Document Name: Report of Board of Public Works of 12/9/20 of request for placement of balcony encroaching City right-of-way at 812/814 S 8th St.,

TO: Mayor and Common Council
FROM: Board of Public Works
SUBJECT: Request for placement of balcony encroaching City right-of-way at 812/814 S. 8th St.

NEW BALCONY FOR:
COFFEY ENTERPRISES
 814 S. 8TH ST. • MANITOWOC, WI

S1.1

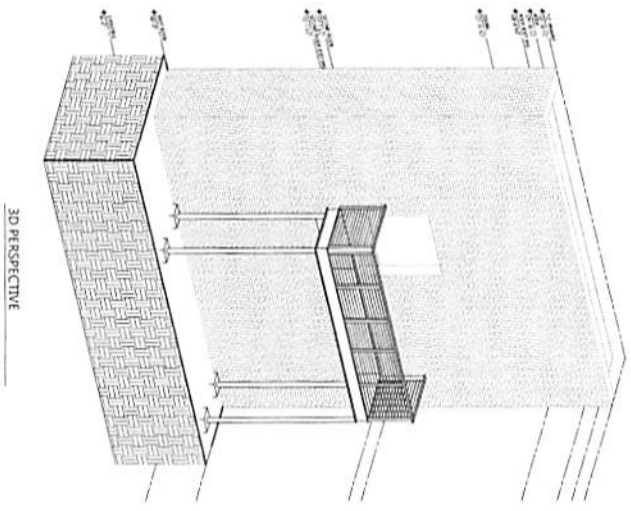
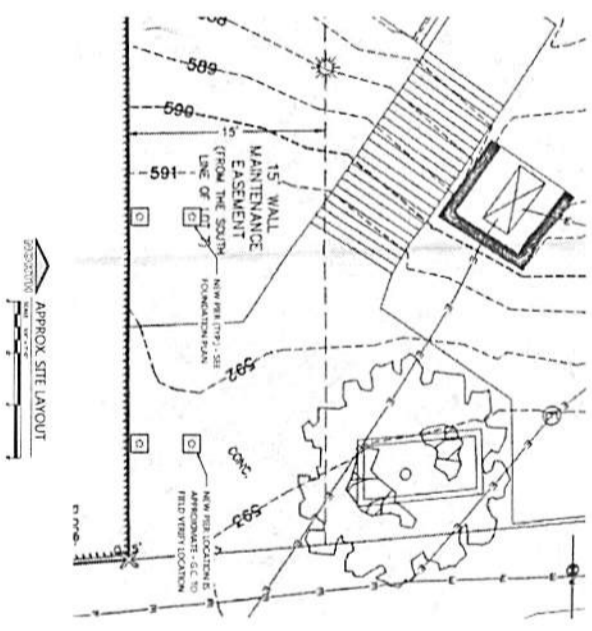
Sonja
Thank you, BTW, for your help on this project. There is one new blueprint sheet I had made up. It shows the overall project overview. See sheet S1.1 below. It will help visualize the finished product.
